LIMERICK GENERATING STATION UNITS 1 & 2

DESIGN ASSESSMENT REPORT

REVISION 6 PAGE CHANGES

FIGURE J.2-1

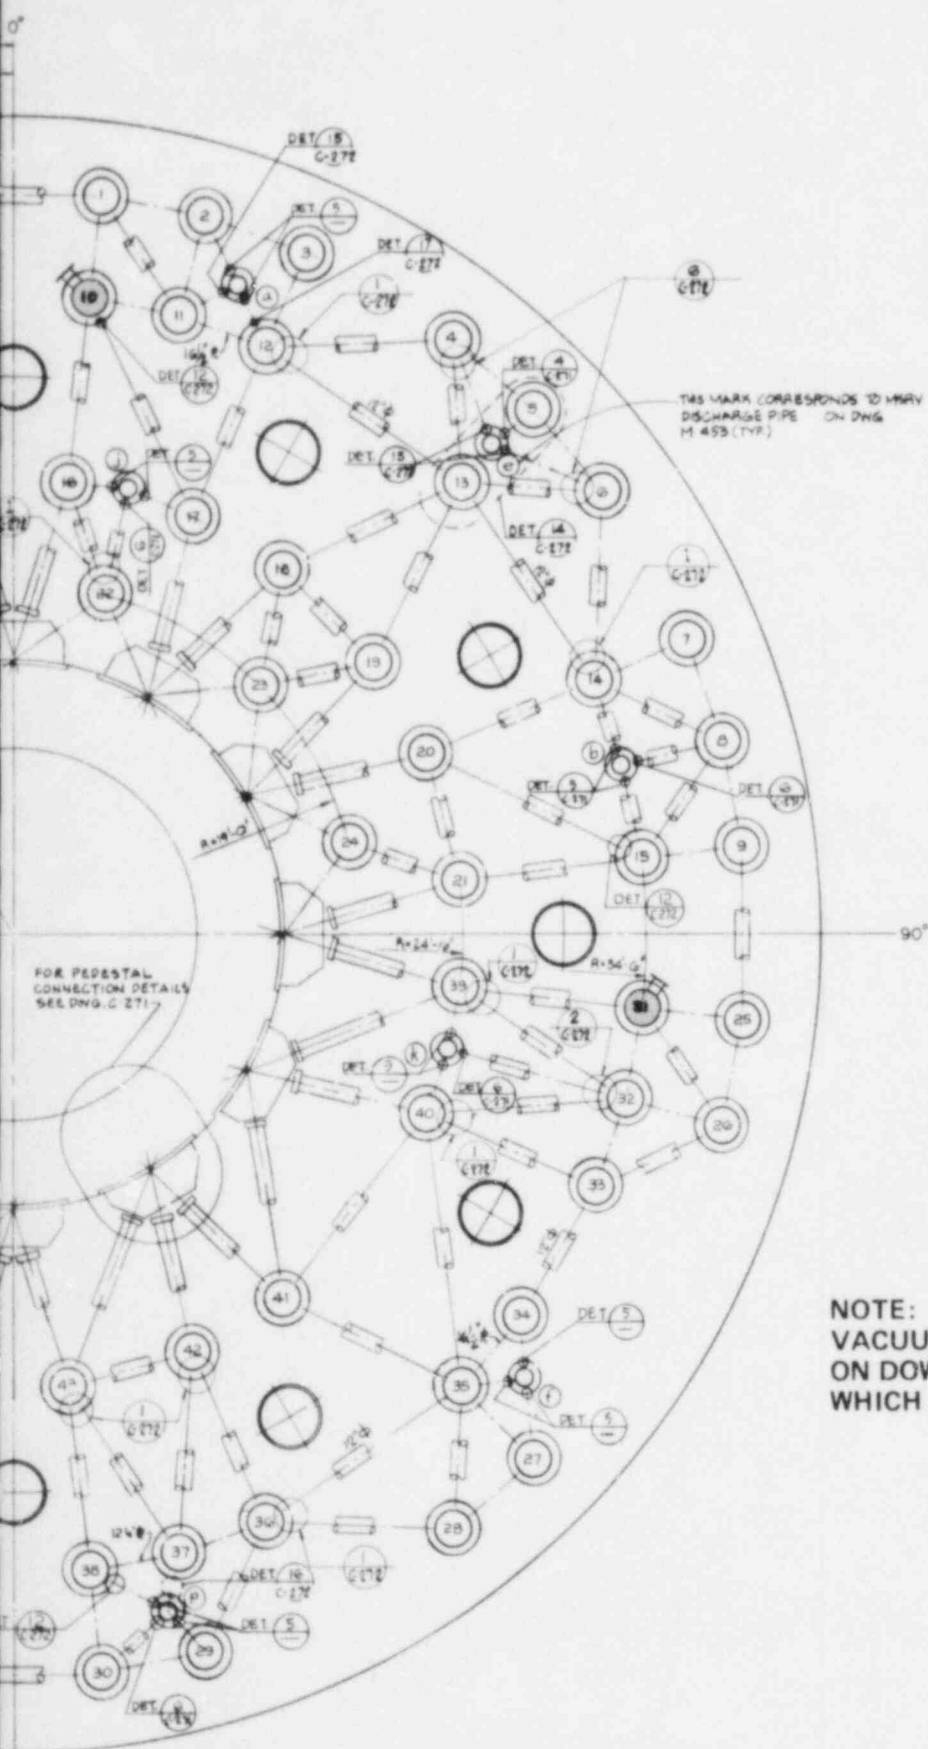
To qualify the Limerick vacuum breakers to withstand the dynamic effects of chugging, the four downcomers on which the wetwell-to-drywell vacuum breakers are mounted have been capped. Capping the downcomers will eliminate the dynamic under and overpressures caused by the sudden steam condensation at the downcomer exit and eliminate the vacuum breaker cyclic actuation due to chugging phenomena. The locations of these capped downcomers are shown in Figure J.2-1.

NOTE:
VACUUM BREAKERS ARE INSTALLED
ON DOWNCOMERS 10, 31, 50 AND 77
WHICH ARE CAPPED (E.G., )

FIGURE J.2-2

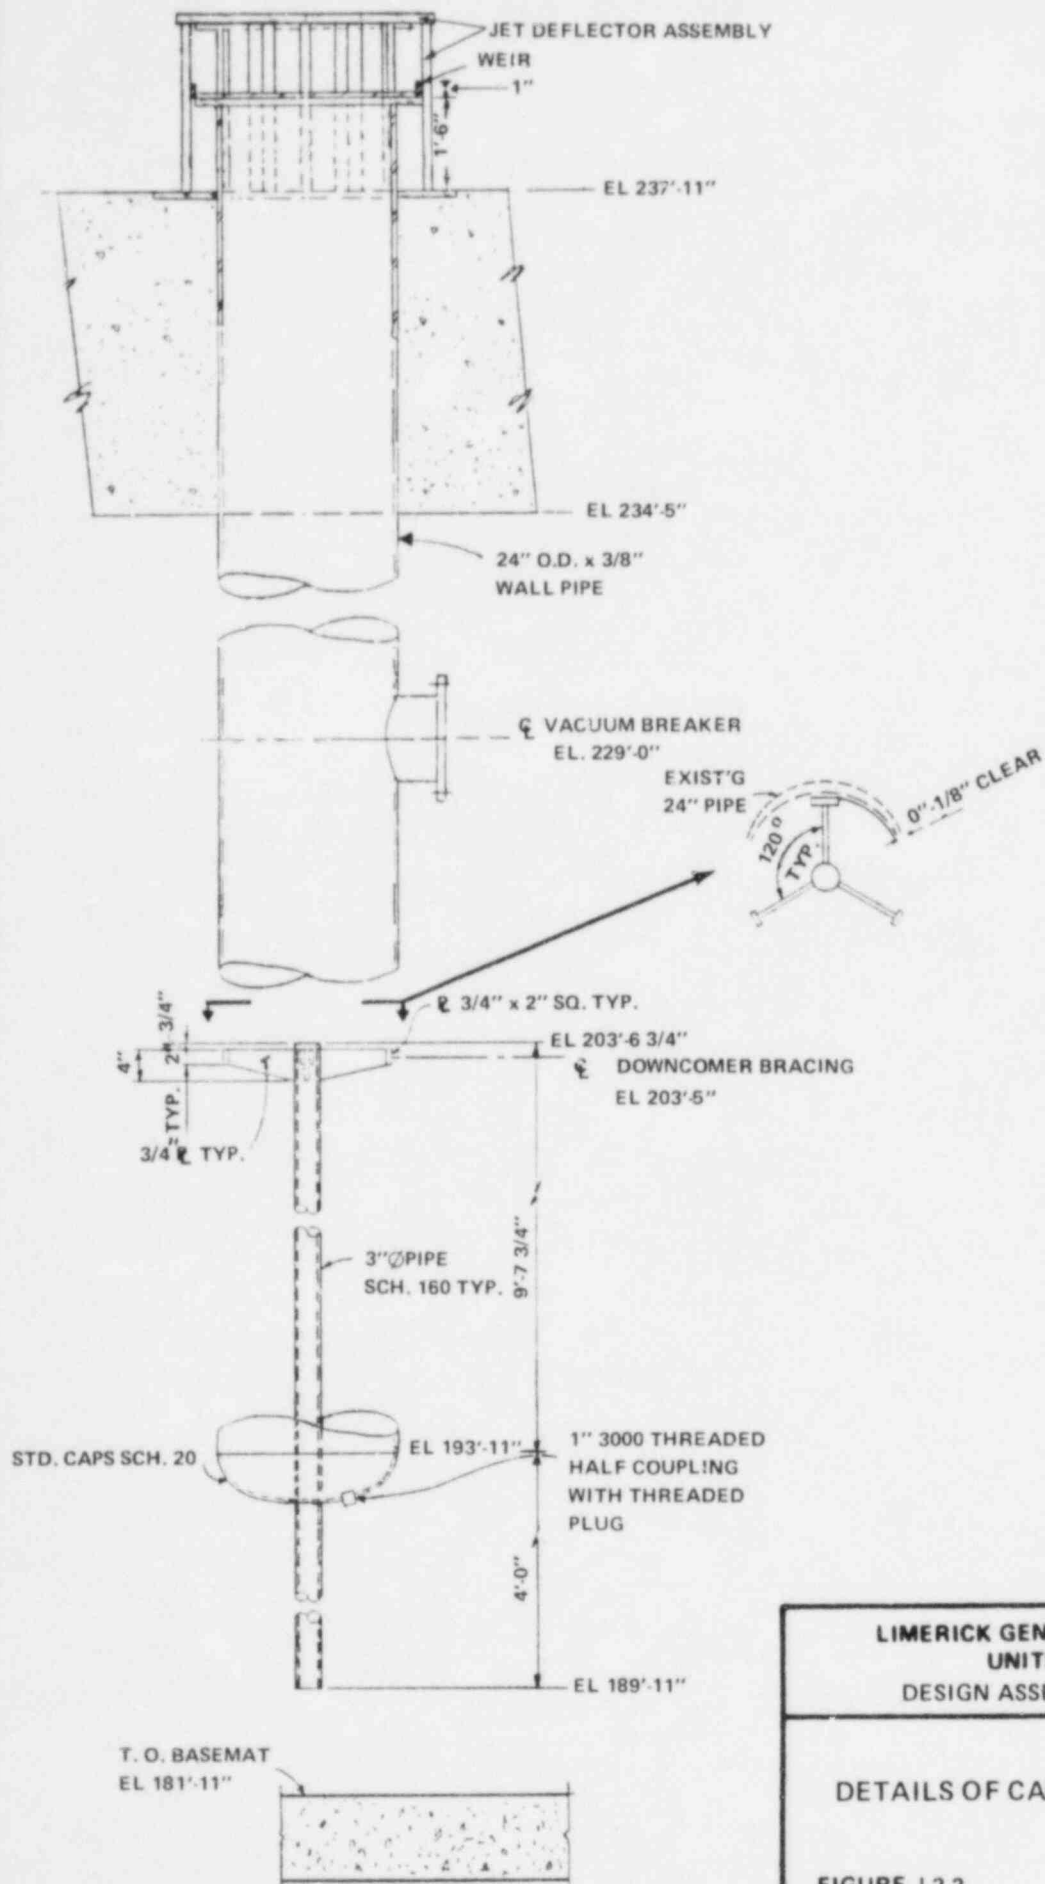
Figure J.2-2 shows a configuration of a modified downcomer with vacuum breaker (typical of four). The modifications include installation of a cap, a 3-inch drain line, and a 1-inch weir at the drywell entrance of the downcomer.

The capping design incorporates a 3-inch Schedule 160 drain line. Water motion in the 3-inch drain line has been modeled. As a result of this work, the drain has been extended 9 ft 7-3/4 inches above the downcomer exit plane. This extended length will prevent water from fountaining into the downcomer during the rapid drywell depressurization caused by the gross chugging at the downcomer exits. In addition, to prevent water from exiting the drain line during the chugging/CO phase of a LOCA, the drain line is extended 4 feet below the downcomer exit plane. Therefore, potential chugging/CO dynamic loading phenomena at the drain exit are precluded.

The addition of a 1-inch weir at the drywell entrance of each capped downcomer is designed to limit the maximum ECCS flow into these downcomers during the recirculation mode after a LOCA. The 3-inch drain line is capable of passing this limited flow of ECCS water while preventing the downcomers from being filled to the vacuum breaker elevation.
